HOLDEN VE AND WM CONDENSER VERSIONS 2006—2012					TSB #:	66
					Date:	03/10/12
Initial Once Read:

Since the release of the VE Commodore and WM Statesman in 2006 there have been some changes to the A/C condenser. Outlined below are the changes that have taken place until now.

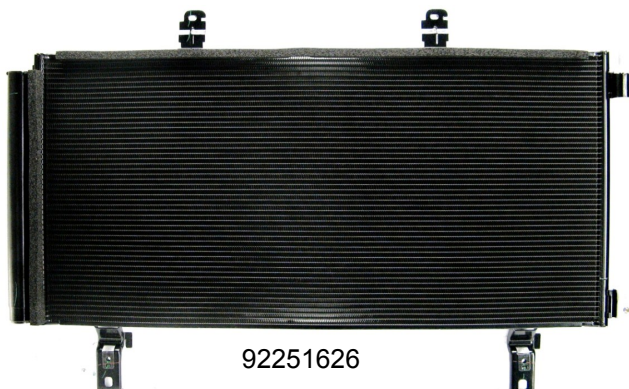
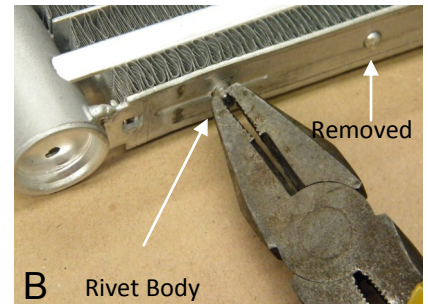
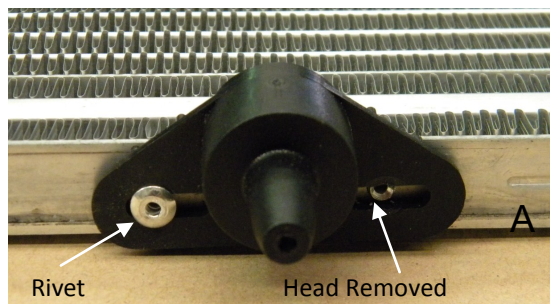
When using condenser CHOL65 to replace OEM part number 92235665 follow the instruction below:

With a 4mm drill bit, drill into the centre of the rivet head used to secure the upper and lower (A) mounting brackets to the condenser. Remove the mounting brackets.

Once all the mounting brackets have been removed use a pair of pliers to wriggle and withdraw the rivet (B) body.

Note: When drilling the rivet do not allow the drill bit to make contact with the condenser tubes otherwise a leak will be created.

Mounting brackets must be REMOVED when using condenser CHOL65 to replace OEM part number 92235665

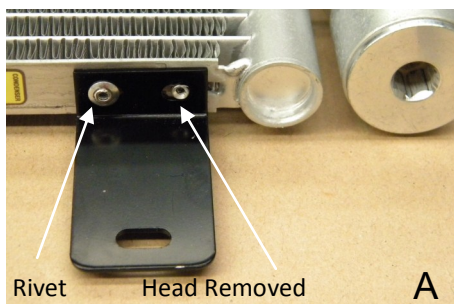
The image (left) shows the condenser to suit Model Year 12.5

An aftermarket version condenser is currently under development
